**SPECIAL PLANNING COMMISSION MEETING
Wednesday, December 03, 2025 at 5:00 PM**

GMS, Inc. has reviewed the drawing set submitted by the applicant for the proposed Highbrook Subdivision project. The documents reviewed are as follows.

1. Site Plan Drawing Sheet 1 of 2 – The Overlook at Palmer Lake, prepared by Crossed Paths Surveying Services, Inc., date of latest revision of August 13, 2025.

1. Site Plan Drawing Sheet 1 of 2 – The Overlook at Palmer Lake, prepared by Crossed Paths Surveying Services, Inc., date of latest revision of August 13, 2025.

TOWN OF PALMER LAKE
VARIABLE WIDTH DRAIN
PIPE EASEMENT
(SEE EASEMENT NOTE 9)

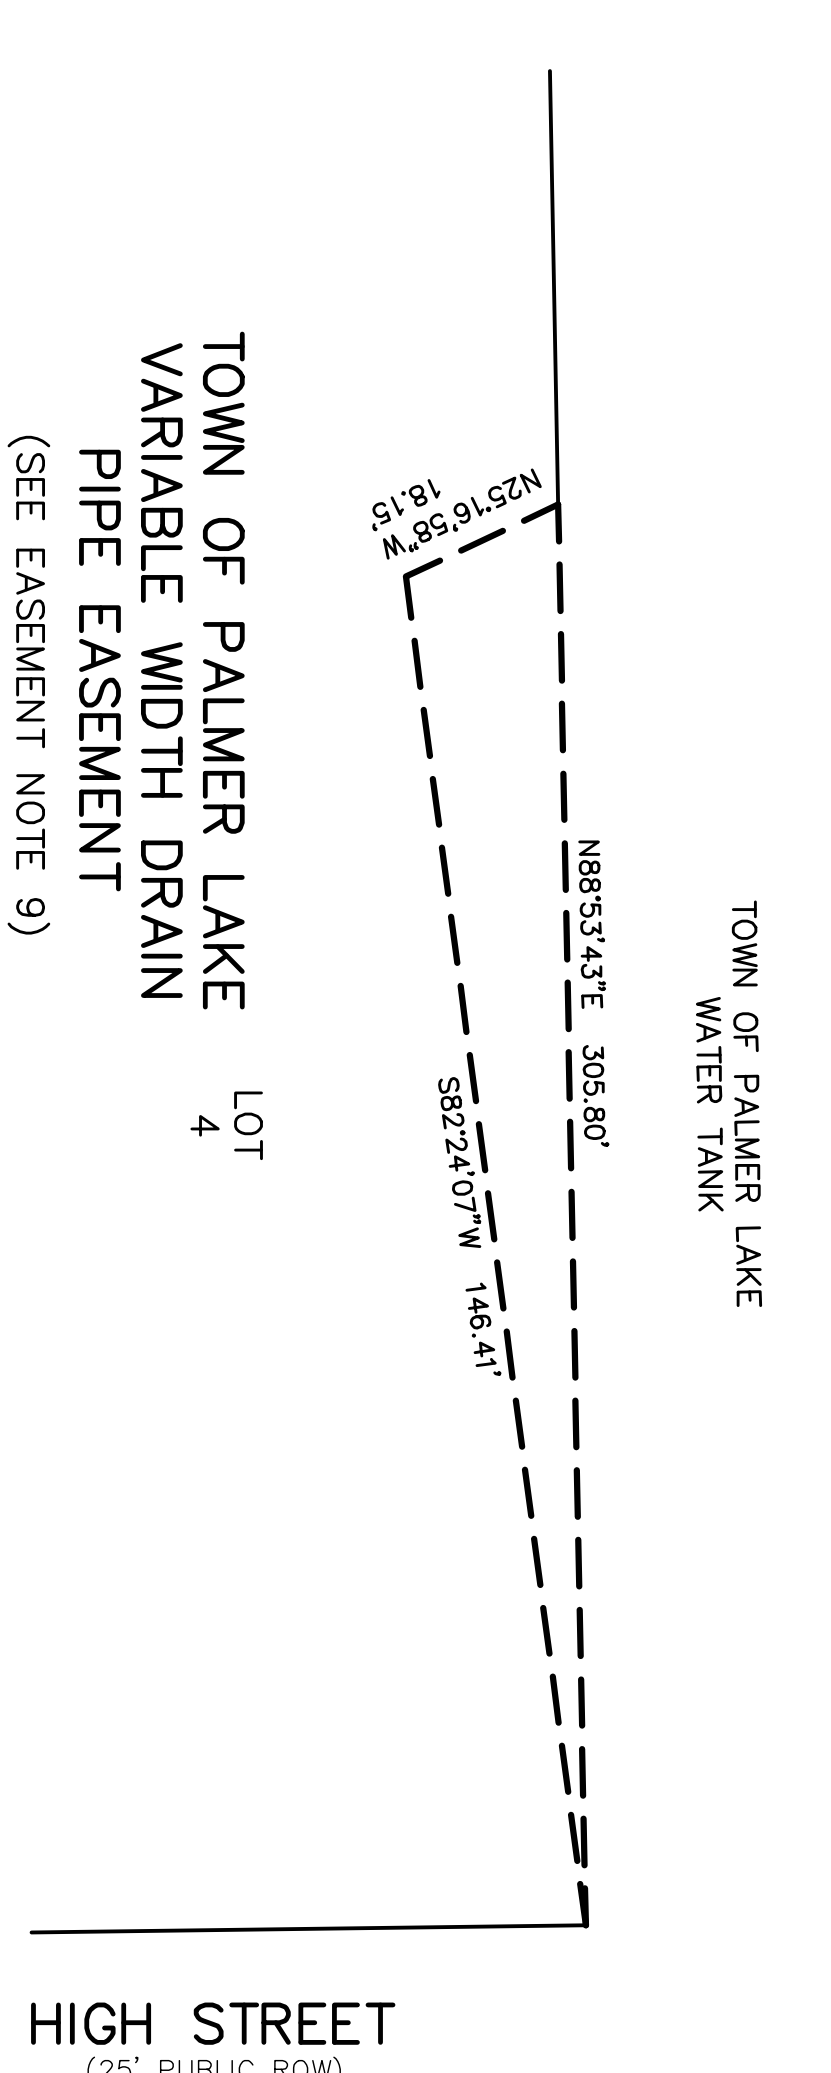
1. Please revise the drawing titles and all references to the project name to state the correct name of Highbrook Subdivision. In accordance with Town Code requirements, resubdivisions shall continue with the previous subdivision name rather than changing the name as presented on the submittal drawings.

- c. The maintenance responsibilities listed in Easement Note #9 must be removed as that information will be specifically defined in the easement agreement documents along with the access priority being with the Town to access the water tank site. Please revise accordingly.

8. Regarding the Private Variable Width Water Drainage Easement referenced to Easement Note 11, please address the following comments:
 - a. It is recommended that the easement be referenced as a Water Drain Pipe easement rather than a Water Drainage easement to avoid confusion in its purpose. Please revise accordingly

- b. As the proposed easement is intended to be dedicated to the Town of Palmer Lake, it is recommended that the easement be noted as a Town of Palmer Lake easement, not a private easement as indicated on the drawings. Please revise accordingly.

- 1. Please revise the drawing titles and all references to the project name to state the correct name of Highbrook Subdivision. In accordance with Town Code requirements, resubdivisions shall continue with the previous subdivision name rather than changing the name as presented on the submittal drawings.

- easement boundary with dimensions from the edge of road to the easement boundary.
- c. The maintenance responsibilities listed in Easement Note #9 must be removed as that information will be specifically defined in the easement agreement documents along with the access priority being with the Town to access the water tank site. Please revise accordingly.

8. Regarding the Private Variable Width Water Drainage Easement referenced to Easement Note 11, please address the following comments:
- a. It is recommended that the easement be referenced as a Water Drain Pipe easement rather than a Water Drainage easement to avoid confusion in its purpose. Please revise accordingly

- b. As the proposed easement is intended to be dedicated to the Town of Palmer Lake, it is recommended that the easement be noted as a Town of Palmer Lake easement, not a private easement as indicated on the drawings. Please revise accordingly.

- G. Plat Drawing Sheet 4 of 4 – As this drawing details multiple individual easements, some of which are proposed for the Town of Palmer Lake, additional coordination on the preparation, execution and recording of these individual easement documents will be required. Refer to reply for comment A.1. above.

SITE PLAN – THE HIGHBROOK SUBDIVISION 2

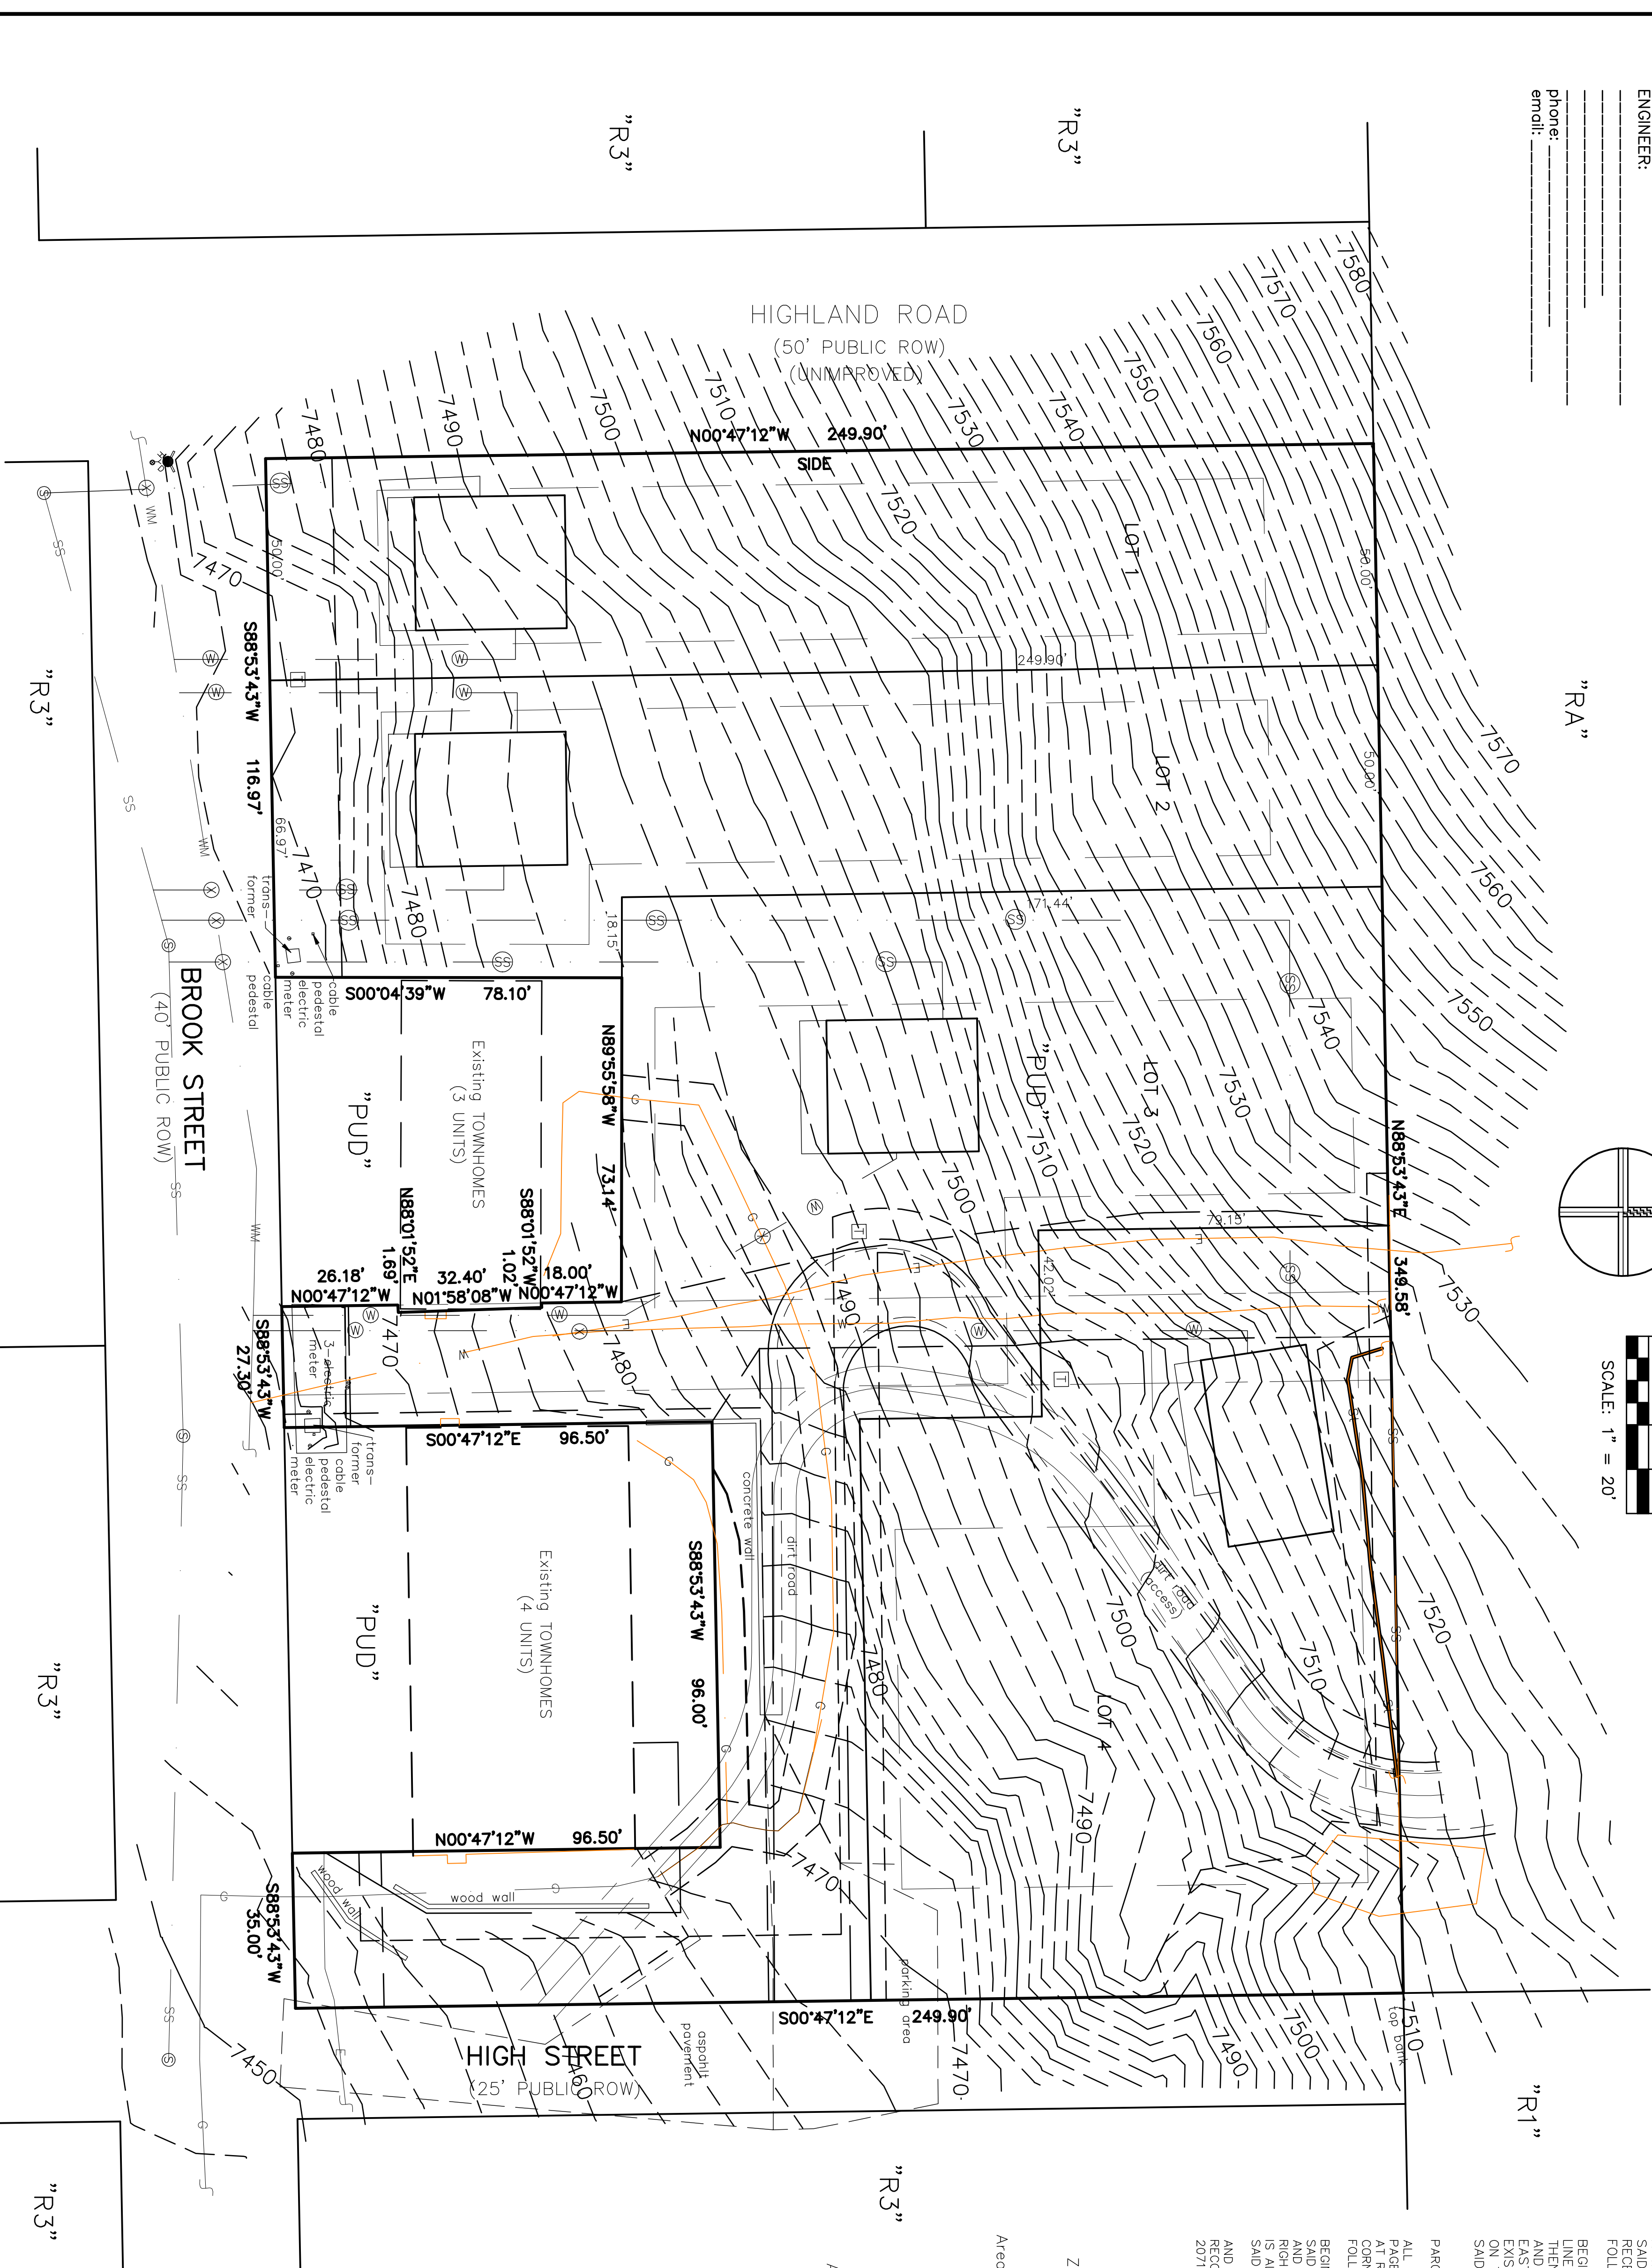
1. Please revise the drawing titles and all references to the project name to state the correct name of Highbrook Subdivision. In accordance with Town Code requirements, resubdivisions shall continue with the previous subdivision name rather than changing the name as presented on the submittal drawings.

1. Please revise the drawing titles and all references to the project name to state the correct name of Highbrook Subdivision. In accordance with Town Code requirements, resubdivisions shall continue with the previous subdivision name rather than changing the name as presented on the submittal drawings. Drawings still reference “The Overlook at Palmer Lake”, additional revisions are required.

2. When fully developed, each proposed lot must conform to the Slope and Stormwater Control requirements in the Town’s current Municipal Code. With the extreme slopes involved, it is recommended that the applicant confirm the average slope of each lot proposed and the feasibility of developing the houses as proposed while meeting the Slope and Stormwater Control requirements for lot area to remain in a natural state. Applicant indicates their engineer has determined the lots are buildable and the required calculations will be shown on individual site plans. As no data or calculations are shown on the resubmittal documents, it is recommended the data and calculations be provided to confirm compliance with Code requirements prior to proceeding.
